HOPE BAY PROJECT

Proponent's Response to Comments Received on the NIRB 2022 Annual Report

September 2023

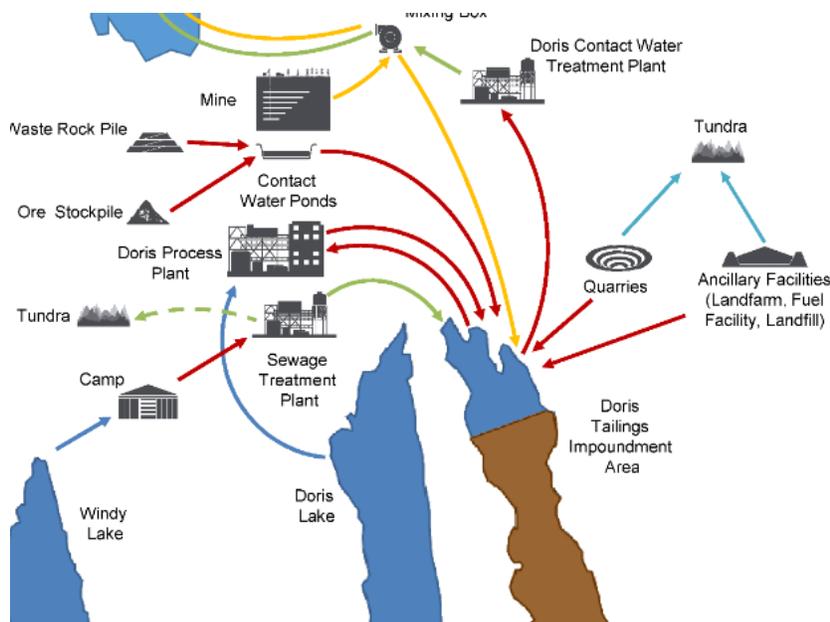
The document does not acknowledge that TIA has been divided in two sections (fresh water and saline water), as described in Chapter 3 of the Annual Report.

The diagrams and the text throughout the document do not take into consideration that part of the TIA will be dedicated to the storage of underground water with high salinity, which will be separated from water with low salinity (fresh water). The two sections have temporarily divided by an interim berm and the construction of long-term water separation within the TIA is underway.
